An Spidéal Pedestrian Crossing

Stage 1 Road Safety Audit

September 2025

Figure 2.1 – Dropped Kerb Near Private Access Leading to Unsafe Crossing Practice

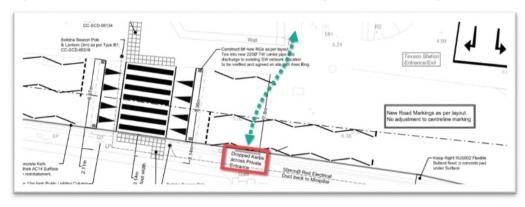
2.1 Problem: Dropped Kerb Encouraging Unsafe Crossing

Location: R336 Southern Footpath Near New Crossing

Installing a dropped kerb at the private access may lead to additional crossing demand at this location, which could increase the risk of conflicts between approaching vehicles and pedestrians attempting to cross the road here.

The proposed dropped kerb near the private access should be removed.

Figure 2.2 - Footpath Widening Will Require Adjustment to Centreline Road Markings

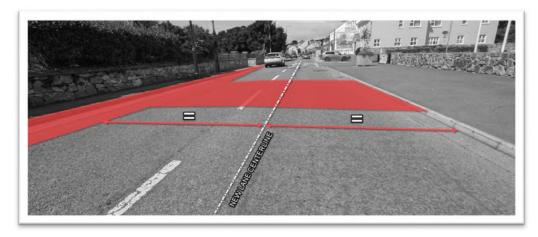
2.2 Problem: Tie-In to Existing Centre Line Road Markings

Location: Road Markings Serving R336 In Proximity to New Crossing

Failing to adjust the existing centreline road markings and yellow box marking to account for the footpath widening could lead to unequal lane allocation, resulting in driver confusion, kerb strikes and head-on type vehicle conflicts.

The existing centre line markings and yellow box markings outside the school entrance should be modified appropriately to ensure a seamless tie-in to the new crossing works.
